REQUEST

Proposed Zoning: MUDD-O (mixed-use development district, optional) and MUDD-O SPA (mixed-use development district, optional, site plan amendment) with 5-years vested rights.

Approximately 45.67 acres located on the west side of South Tryon Street, north side of Clanton Road, and east side of Interstate 77.

The petition proposes a mixed-use development on parcels that are currently developed with light industrial, office, and commercial uses.

• Proposed Request Details

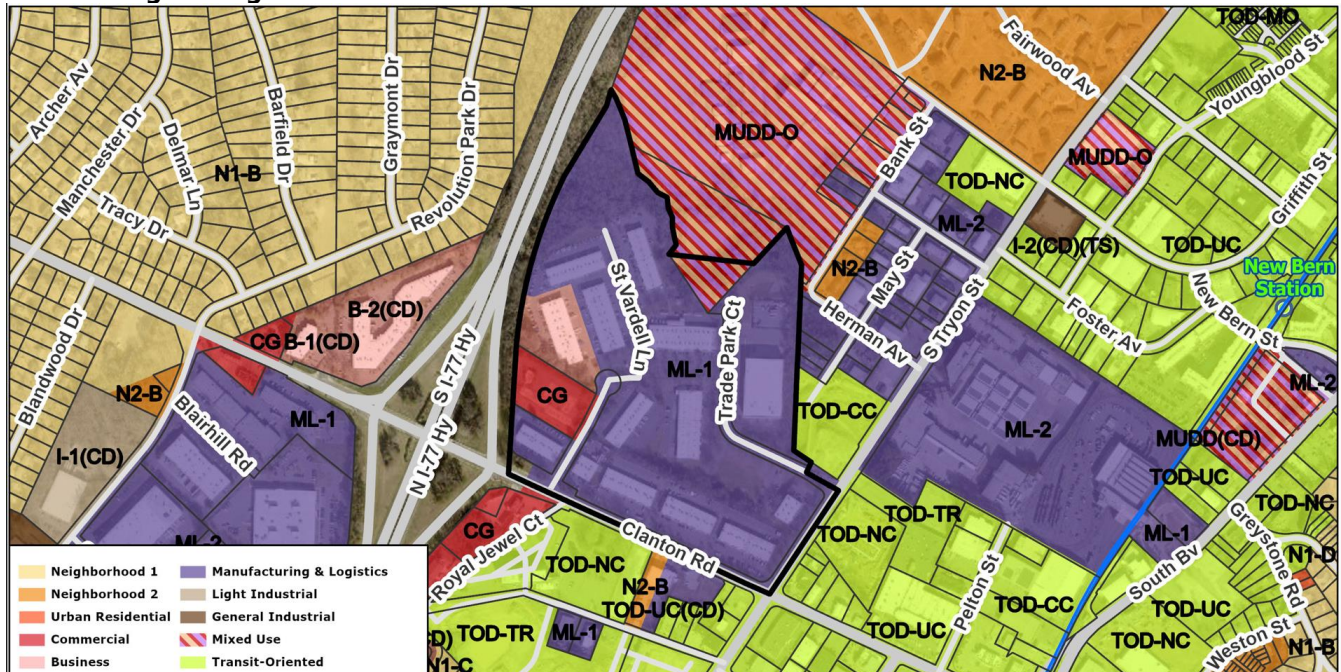
- Allows all uses permitted by-right and under prescribed conditions in the MUDD zoning district together with accessory uses. Prohibits automotive service/gas stations with accessory car washes, commercial self-storage facilities, and drive-in windows outside of ~~Development Areas A and D~~ Development Area A2. There shall be no more than one gas station and two accessory drive-through windows in Development Area A2.

- Allow a maximum building height of 180 feet.
 - Allow drive-in windows as an accessory to the principal uses located in **Development Area A2** ~~Development Areas A and D~~. For a restaurant/bar principal use to have an accessory drive-through, it must have a minimum of 24 seats.

- Commits to a contribution of 50,000 for roadway or multi-modal improvements in the general South End area.
 - **25 EV-ready spaces will be installed prior to Phase 2.**

- **An ADA compliant bus stop shall be provided along Clanton Road in coordination with CATS.**

- Gas stations must meet the standards of the district with the exception of minimum building length as a percentage of lot width and **will have a minimum ground floor height of 14'.**

- **May have a maximum of 8 pumps.**
 - **Canopies shall be located to the rear or side of the principal building.**
- Provides design standards for accessory drive-throughs:

- **Drive through lanes and drive aisles may not be located between primary streets and the façade of the building.**
 - Drive-through lanes and aisles located between the street and façade of a building shall require parking lot screening.

- A drive-through lane shall have bail out capability.
 - **Seatwalls may be used to enhance the pedestrian environment.**
- Commits to providing a minimum of 30% more open space than required in the MUDD district. Additionally, the petitioner shall either increase open space by an additional 20% for a total of 50% above MUDD requirements or donate \$250,000 towards the improvements of a park near the site.
